User Friendly & Comfortable Design EN81-70:2018-compliant

Convenient features ensuring compliance with EN81-70:2018

Symbol color

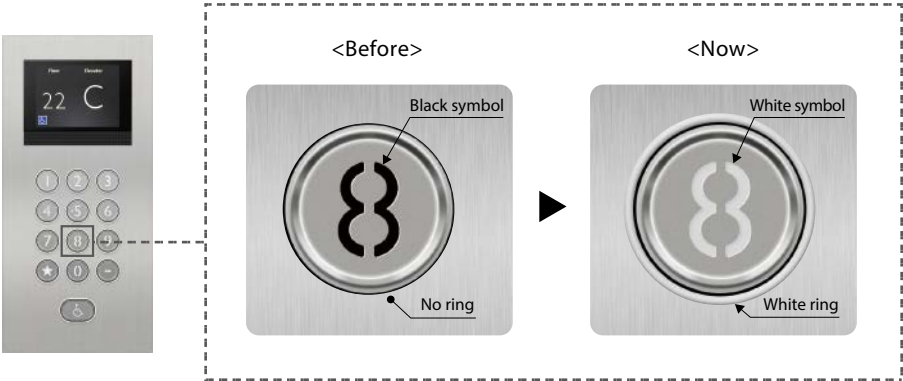
The color of the symbol on keypad buttons has been changed from black to white to increase luminance contrast.

2 Enhanced Visibility of Landing Control Devices

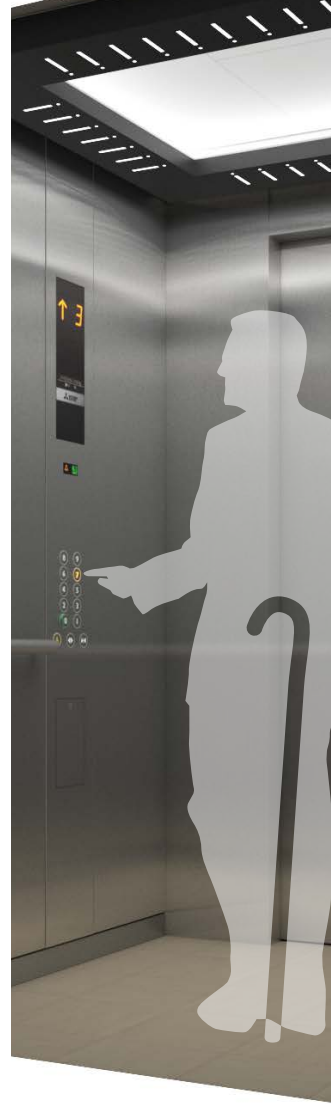
The LRV requirement also applies to landing control devices. A faceplate frame has been added for landing control devices such as hall button panels, hall position indicators. The frame draws a clear border between the panels and building wall.
